Technical Service Bulletin: TSB110079

New ISX and QSX15 Cylinder Liner

Old Cylinder Liner, Part Number 4101507 and New Cylinder Liner, Part Number 2882764

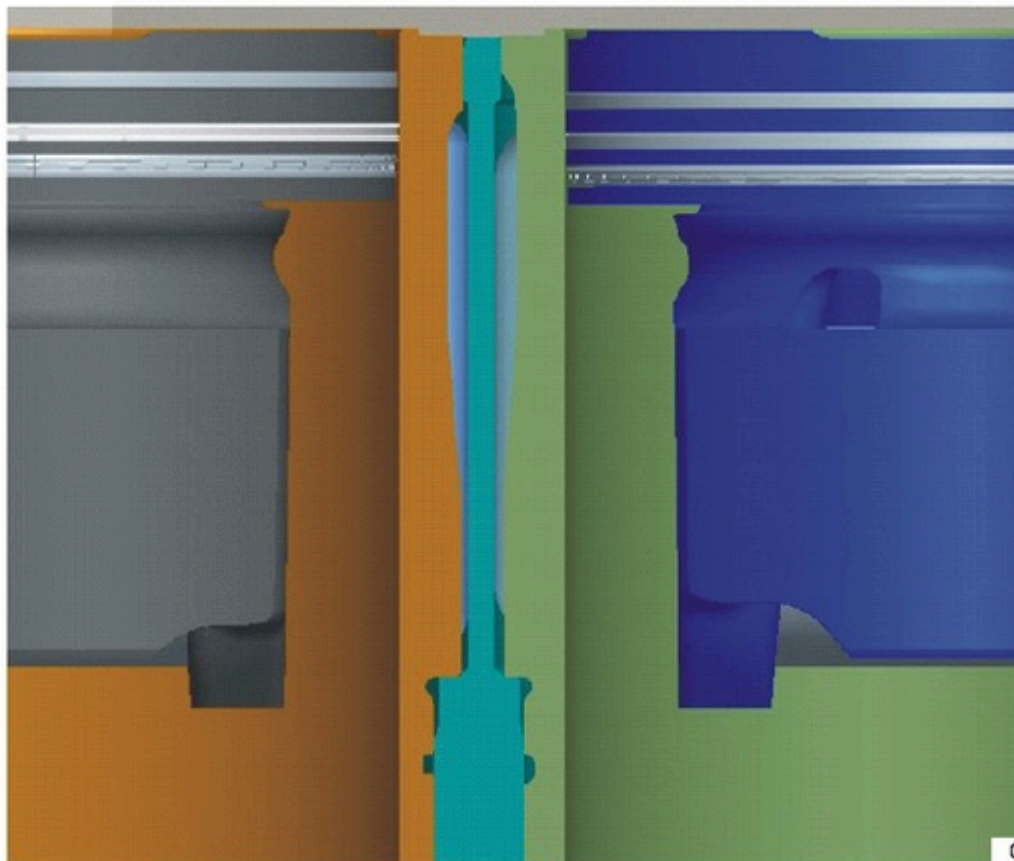
This document introduces a new ISX and QSX15 cylinder liner. This new liner has the thickness of the top press fit ledge reduced. This reduced press fit ledge allows for better cooling of the top ring reversal area, which improves the liner's resistance to wear in this area.

The new liner is completely backwards compatible and can be mixed and matched in an engine.
